From: [REDACTED]
To: [Baths Quays Links](#)
Subject: consultation 25-052 "Bath City Centre walking, wheeling and cycling proposals - statutory consultation"
Date: 11 December 2025 12:48:48
Attachments: [image001.png](#)
[image002.png](#)
[image003.png](#)

From: [REDACTED]
To: [Baths Quays Links](#)
Subject: TRO Ref. 25-052 VARIOUS ROADS, CENTRAL AREA, BATH, PROHIBITION OF STOPPING, WAITING, LOADING AND PARKING PLACES
Date: 08 January 2026 14:36:18
Attachments: [3174 The Min Bath Technical Note Servicing Deliveries Nov25 Final.pdf](#)
[3174 26.01.07 Upper Borough Walls TRO 25-052 PFP Reps Final.pdf](#)

PERMANENT TRAFFIC REGULATION ORDER, UPPER BOROUGH WALLS – TRO REF 25-052

TECHNICAL NOTE ON HOTEL SERVICING AND DELIVERIES

PEP Option Drawings

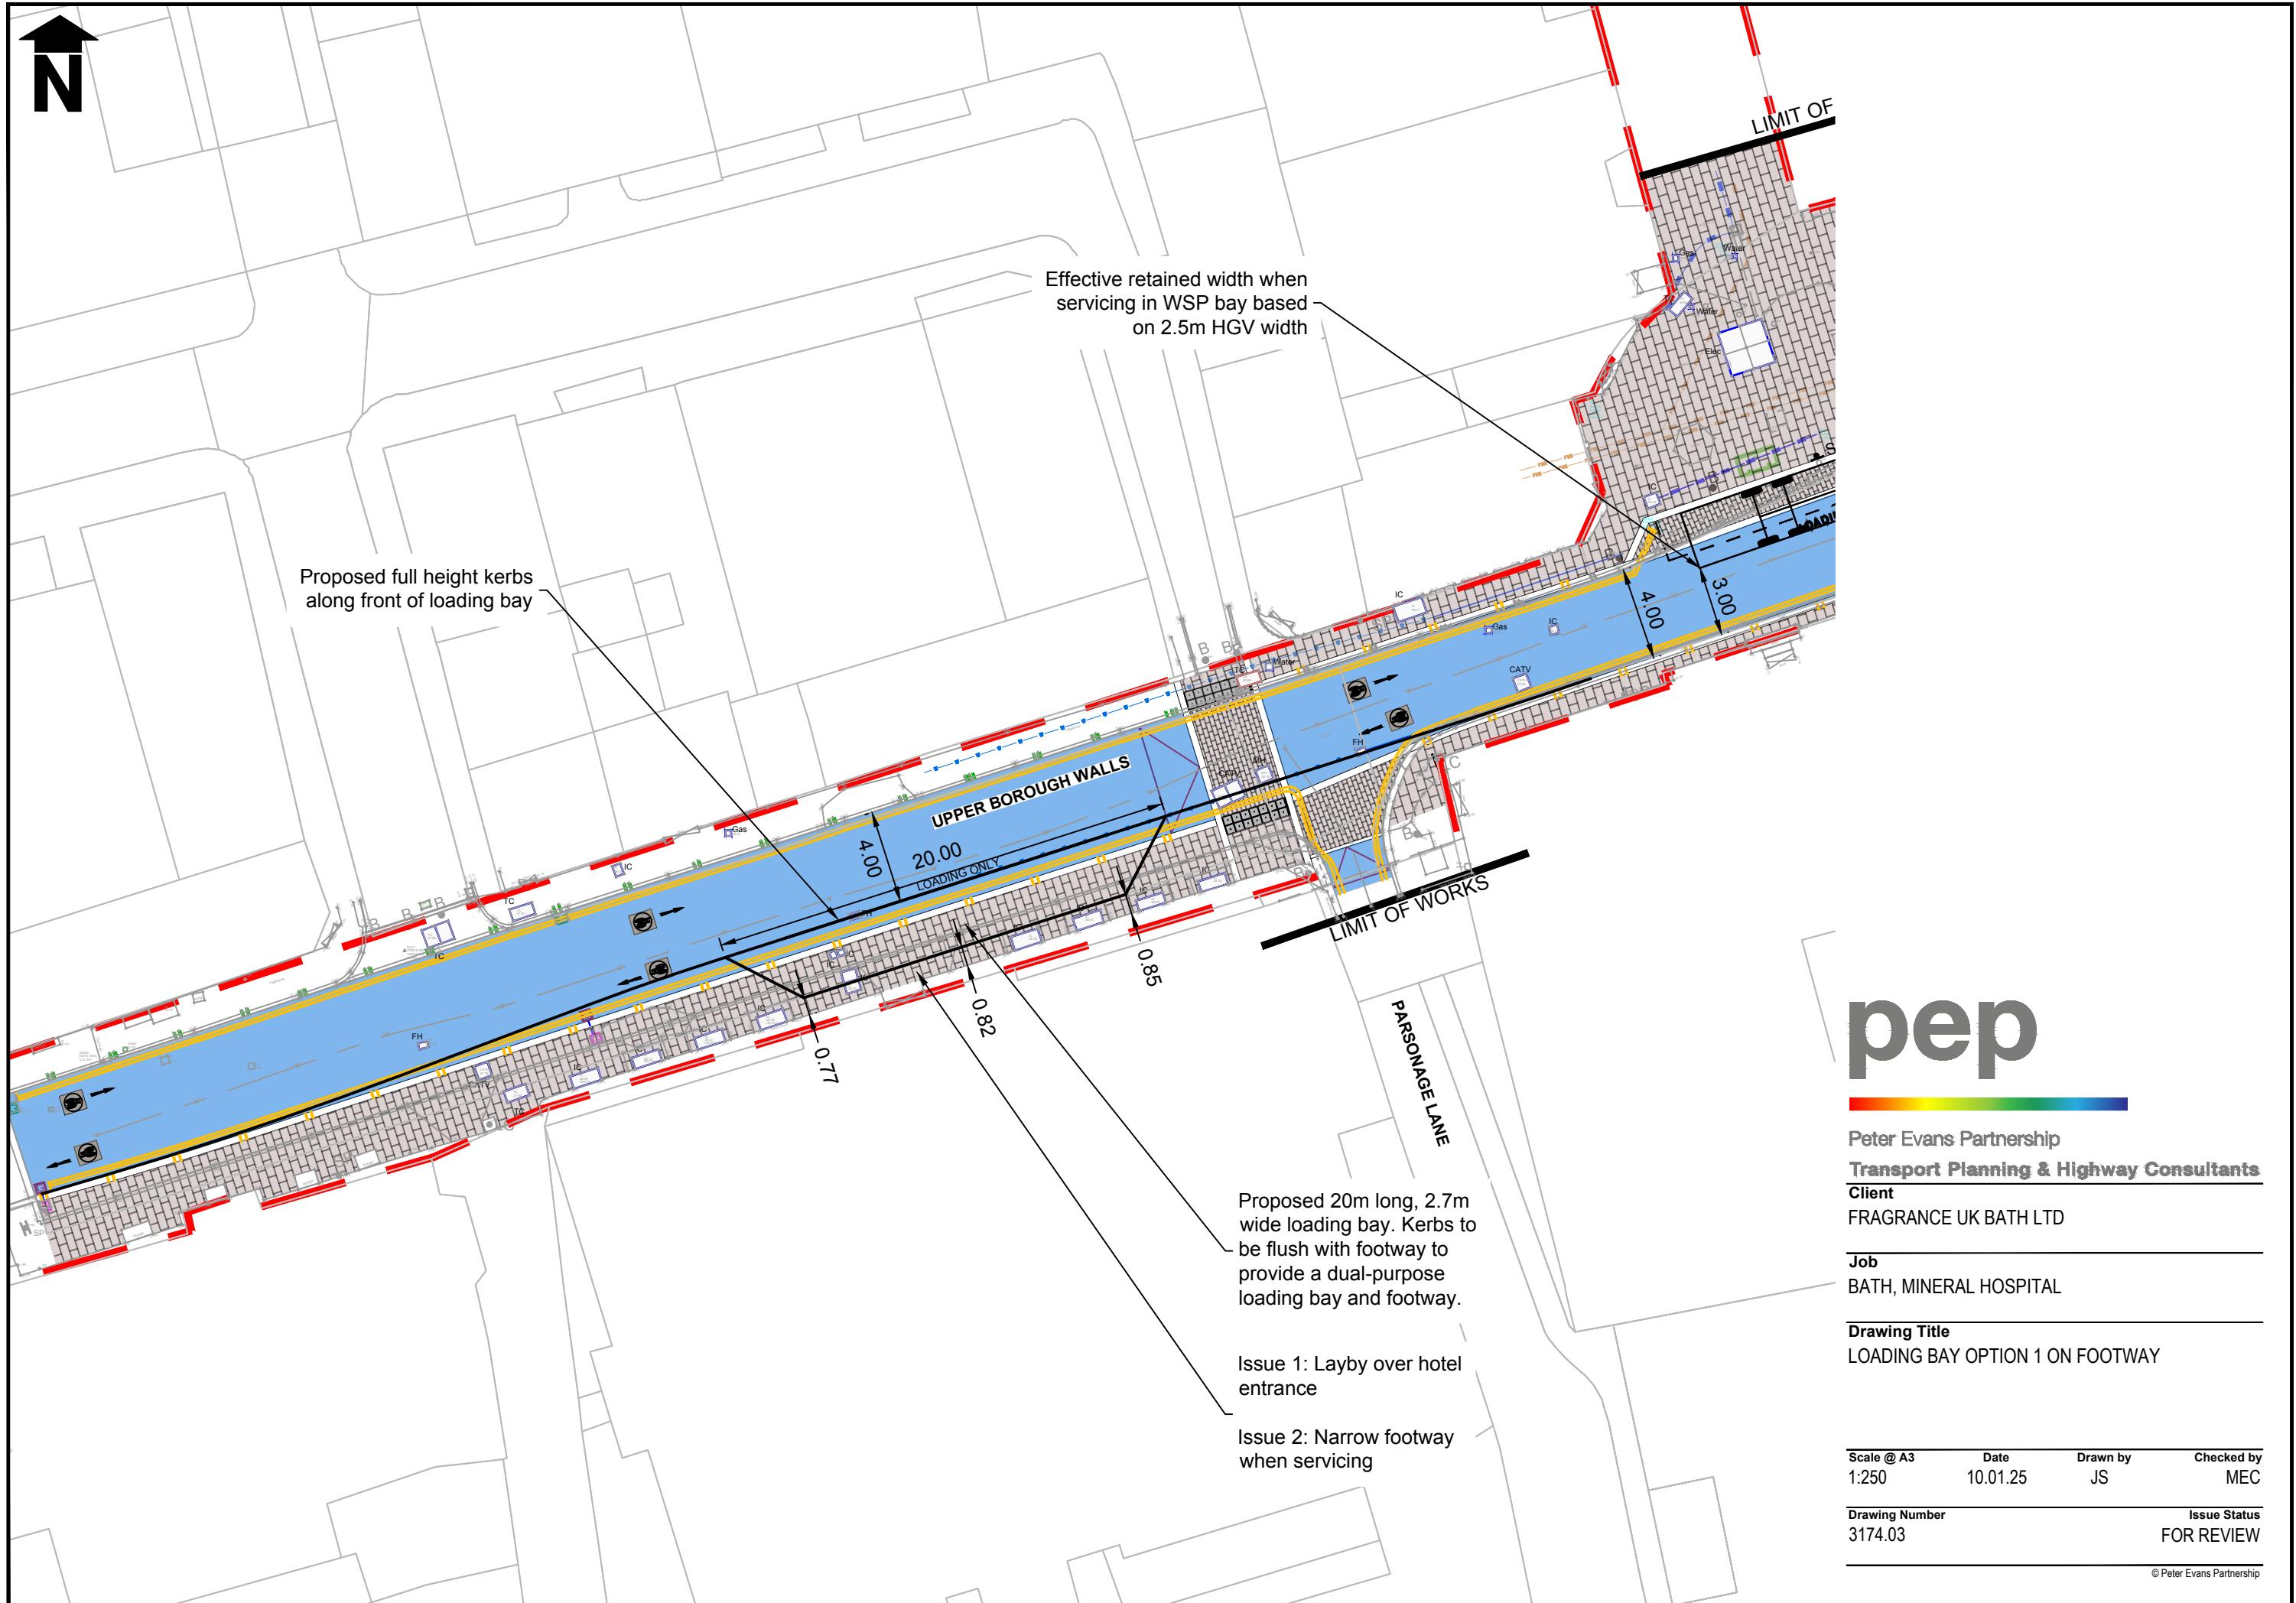
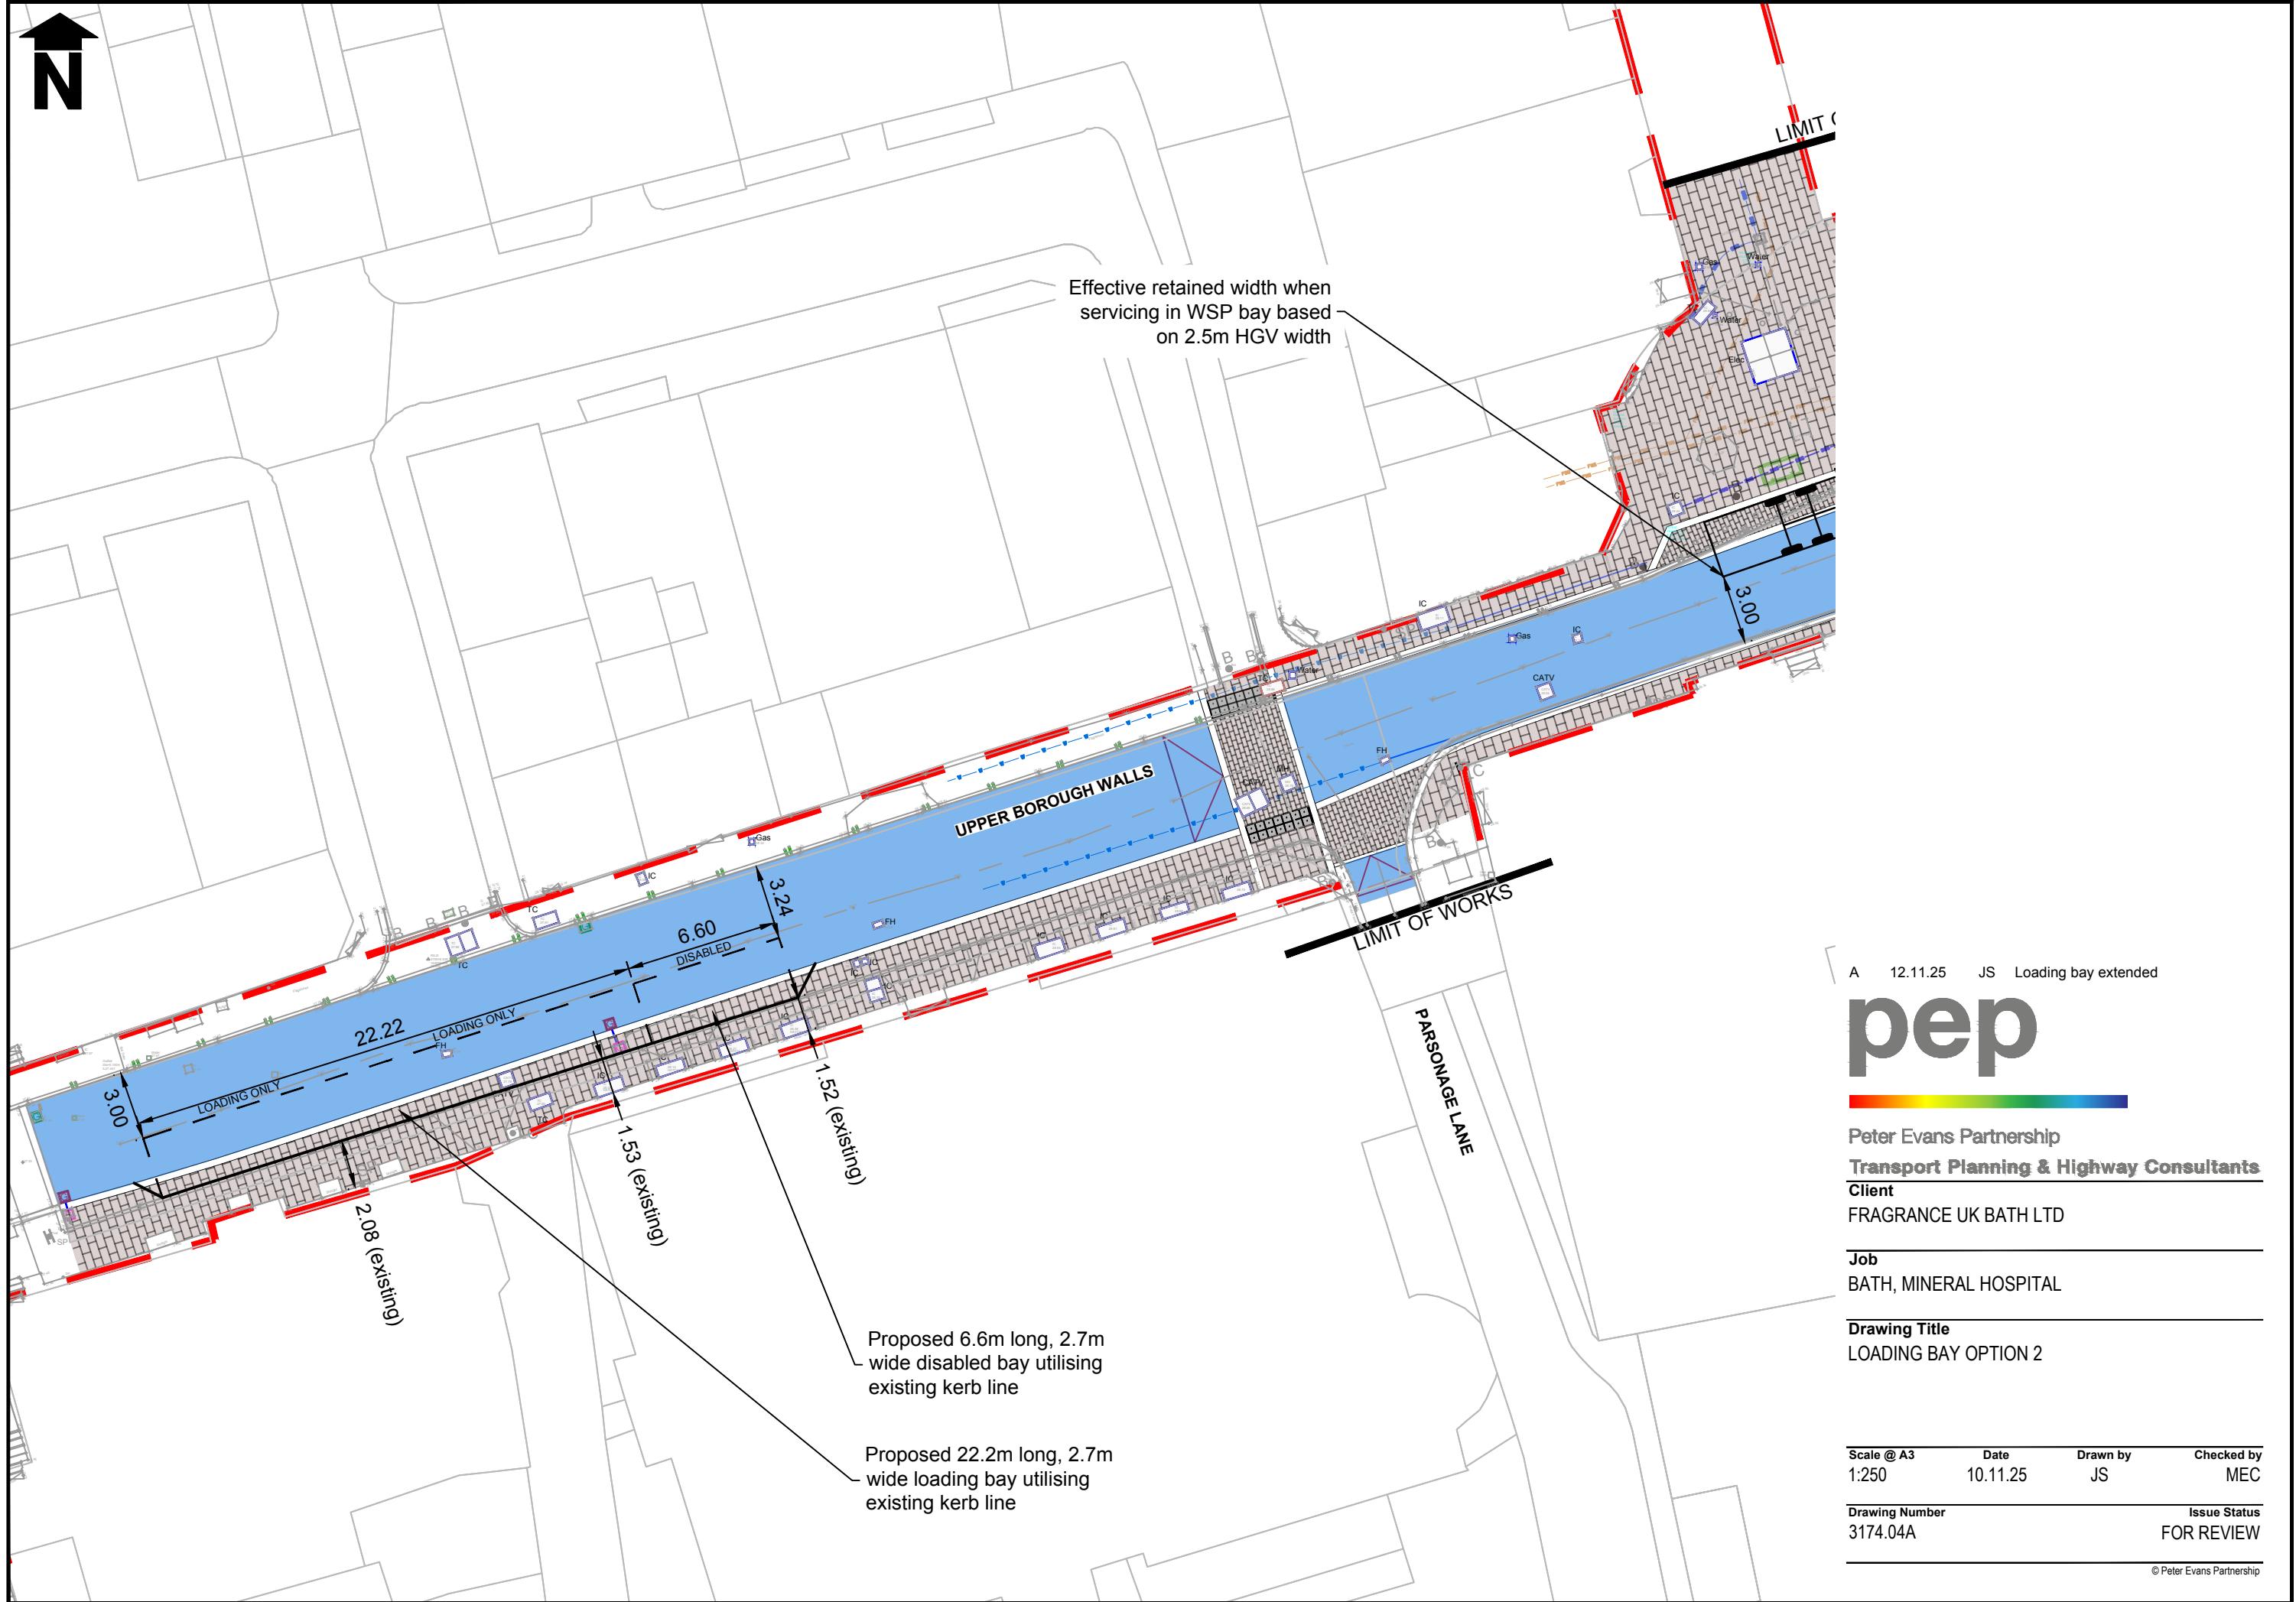
- Option 1 - an off carriageway loading bay within the widened footway outside the West block.
- Option 2 - a loading bay and disabled bay partly within the footway and partly within the carriageway.
- Option 3 - a loading bay partly within the footway and partly within the carriageway.
- Option 4 - a loading bay and disabled bay partly within the footway and partly within the carriageway on either side of the West block entrance.

4.3.3 The off carriageway loading bay would be within the proposed widened footway and flush with the footway. This would be 20m long and 2.7m wide. It would narrow the footway adjacent to the West block in front of the proposed hotel entrance, but as it is flush it would be shared and open for use by pedestrians when not needed for loading. A carriageway width of 4m would be retained past the loading bay, which would allow a vehicle to comfortably pass a cyclist.

- 4.3.5 The loading bay would be 22m long and 2.7m wide. It would retain a 1.5m footway width in front of the West block following the existing kerb line.

4.3.11 Options 2 and 4 are considered to be the preferred options as they would provide a sufficient sized loading bay for the proposed hotel and other local businesses and traders, maintaining a carriageway width for vehicles and contra flow cycling consistent with the BANES/WSP arrangement on the north side of UBW, without narrowing the footway. Both options provide a disabled parking, but by separating the loading and disabled bay in Option 4 would create more space in front of the building entrance for pedestrians entering and leaving the proposed hotel.
